PIC16C924 Rev. A Silicon/Data Sheet Errata

The PIC16C924 (Rev. A) parts you have received conform functionally to the Device Data Sheet (DS30444E), except for the anomalies described below.

FIGURE 1: SCK PULSE VARIATION USING TIMER 2/2

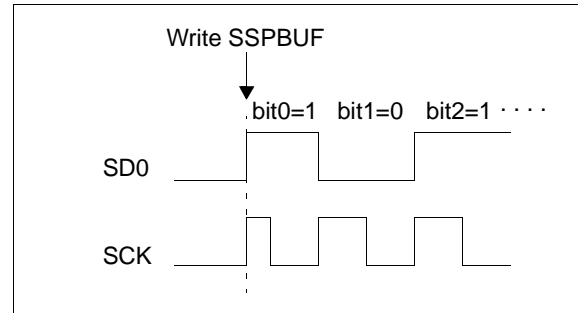
When the SPI is using Timer2/2 as the clock source, a shorter-than-expected SCK pulse may occur on the first bit of the transmitted/received data (see Figure 1).

To avoid producing the short pulse, turn off Timer2 and clear the TMR2 register, load the SSPBUF with the data to transmit, and then turn Timer2 back on. Refer to Example 2 for sample code.

FIGURE 1: WRITES TO TIMER1 (EXTERNAL CLOCK / OSCILLATOR MODE)

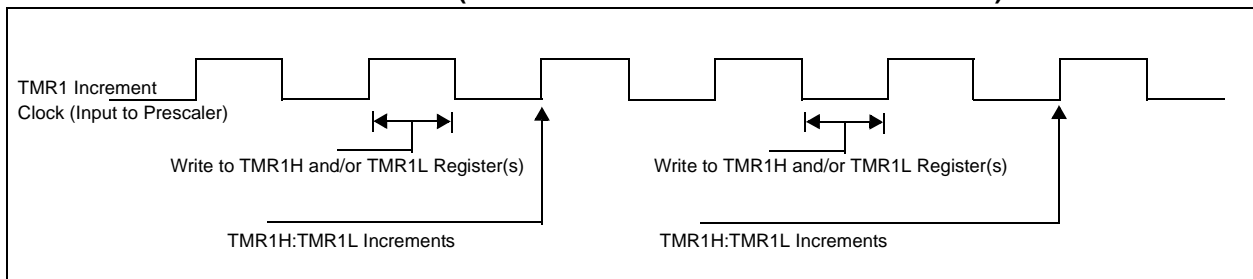
The operation of Timer1 needs some clarification when the timer registers are written and the TMR1ON bit is set.

The internal clock signal that is the input to the TMR1 prescaler affects the incrementing of Timer1 (TMR1H:TMR1L registers and the Timer1 prescaler). When the Timer1 registers are NOT written, the Timer1 will increment on the rising edge of the TMR1 increment clock.

When the TMR1H and/or TMR1L registers are written while this clock is high, TMR1 will increment on the next rising edge of this clock.

When the TMR1H and/or TMR1L registers are written while this clock is low, TMR1 will not increment on the next rising edge of this clock, but must first have a falling clock and then the rising clock for TMR1 to increment.

Figure 1 shows the two cases of writes to the TMR1H and/or TMR1L registers. Due to the V_{IH} and V_{IL} thresholds on the oscillator/clock pins, external Timer1 oscillator components, and external clock frequency, the Timer1 increment clock may not be of a 50% duty cycle.

FIGURE 2: PORTC BLOCK DIAGRAM (PERIPHERAL OUTPUT OVERRIDE)

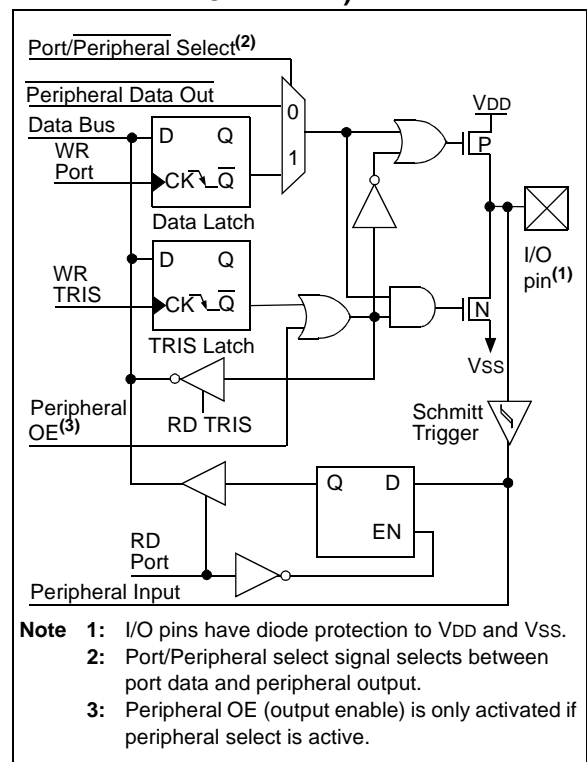
The block diagram for PORTC presented in Figure 5-5 of the Device Data Sheet (DS30444E) is incorrect. The correct block diagram is shown in Figure 2.

FIGURE 3: WAVEFORMS IN 1/2 MUX, 1/3 BIAS DRIVE

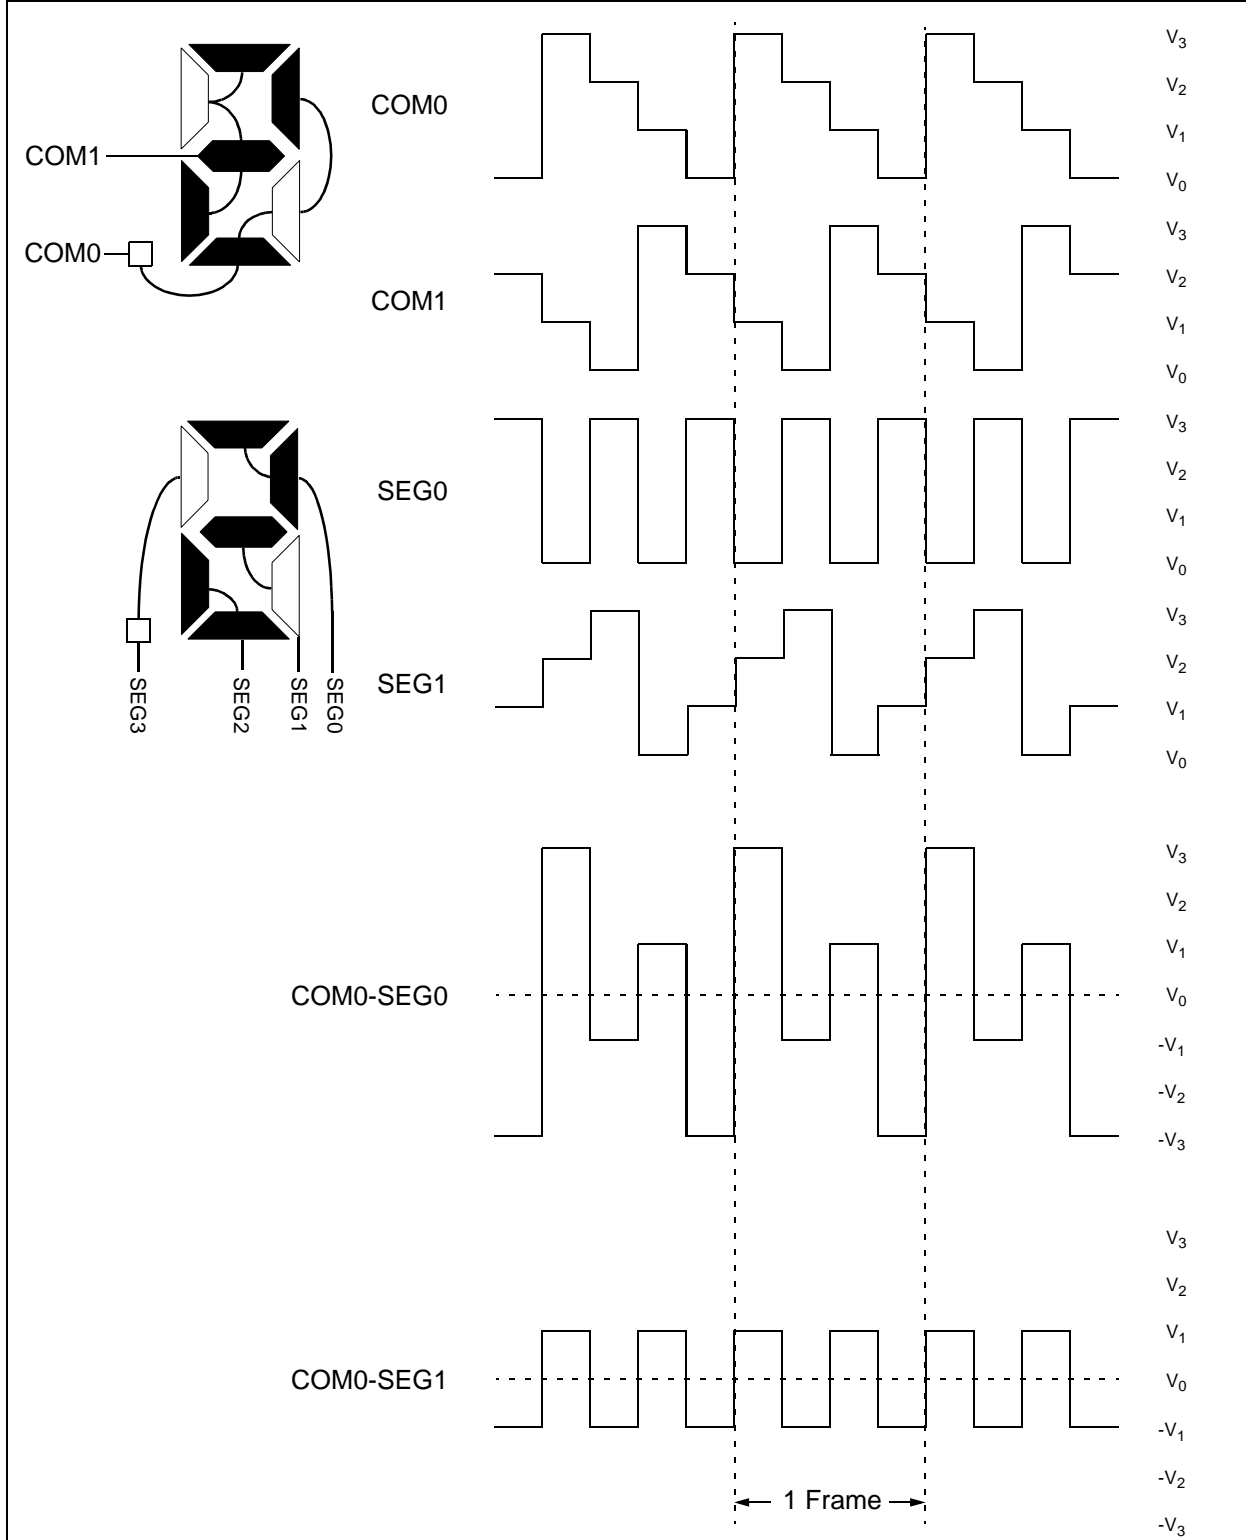
Figure 13-5 in the data sheet, depicting drive waveforms in 1/2 multiplex, 1/3 bias mode, is incorrect. Specifically, the connections for the

different LCD segments (SEG0 through SEG4) and the SEG1 drive waveform have been changed. The correct diagrams and waveforms are shown in Figure 3.
